**RE: PETITION NO. 1561** - Bloom Energy Corporation petition for a declaratory ruling, pursuant to Connecticut General Statutes §4-176 and §16-50k, for the proposed construction, maintenance and operation of a customer-side 350-kilowatt fuel cell facility and associated equipment to be located at Naugatuck Valley Community College, 750 Chase Parkway, Waterbury, Connecticut.

**Petition No. 1561  
Bloom Energy Corporation (Bloom)  
Naugatuck Valley Community College  
750 Chase Parkway  
Waterbury, Connecticut  
Interrogatories**

**Attachment #2: Concrete Washout & Storm Drain Details**

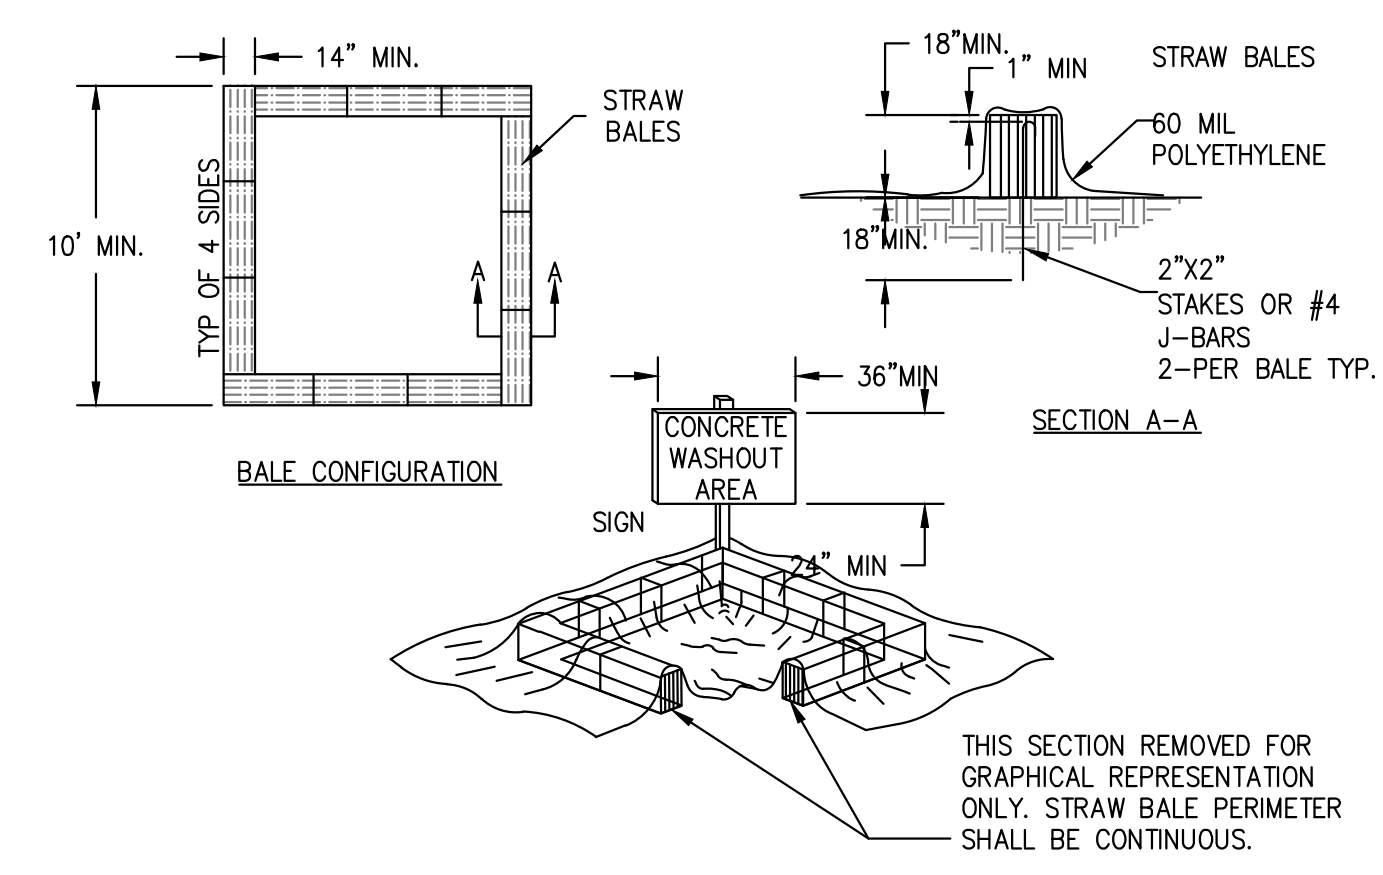
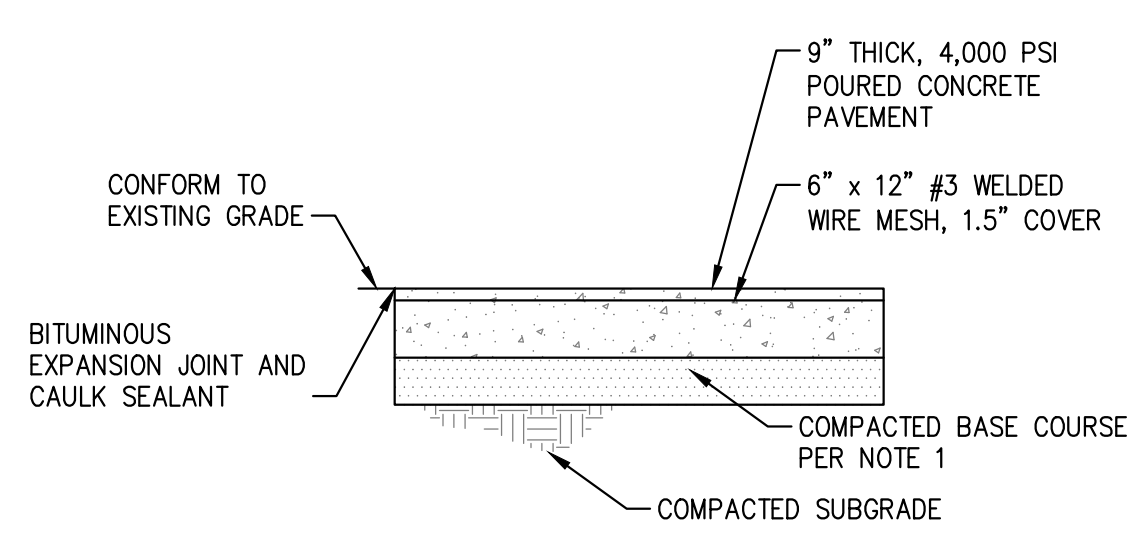
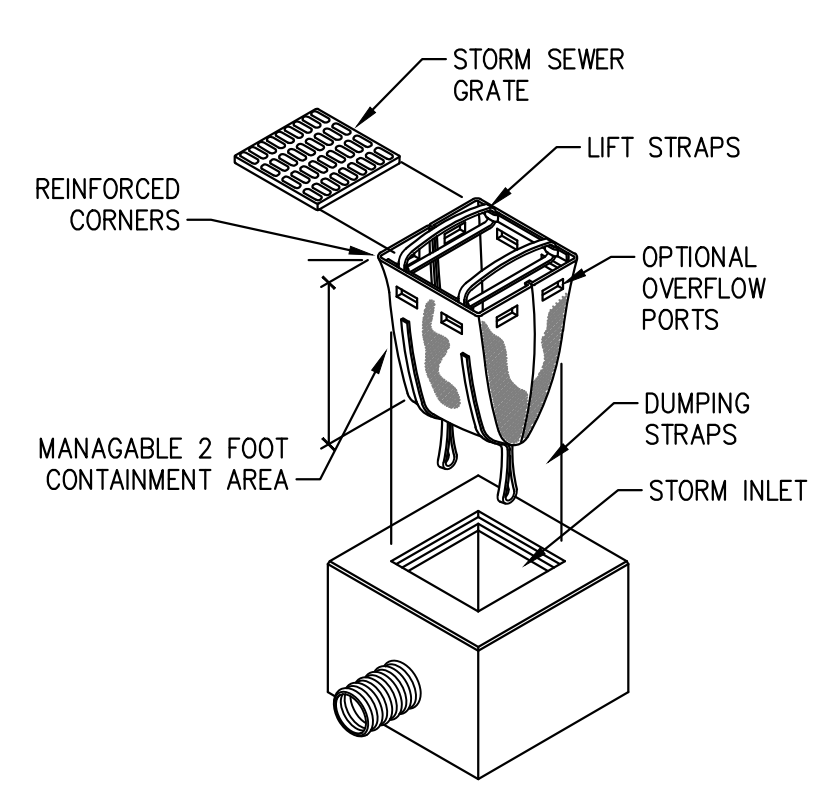
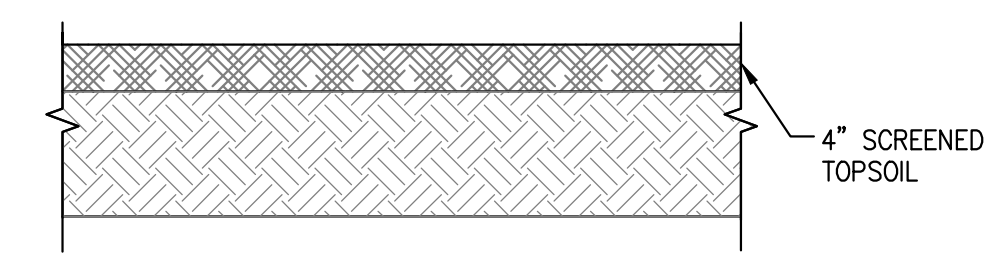
16. What is the distance of the proposed facility to Welton Brook and the pond southwest of the facility? Would any erosion and sedimentation control measures be implemented, consistent with 2002 *Connecticut Guidelines for Erosion and Sediment Control*, and/or any additional measures be taken to protect these resources? Explain.

**Response: Typical concrete washout and storm drain details are provided; please see Attachment #2.**
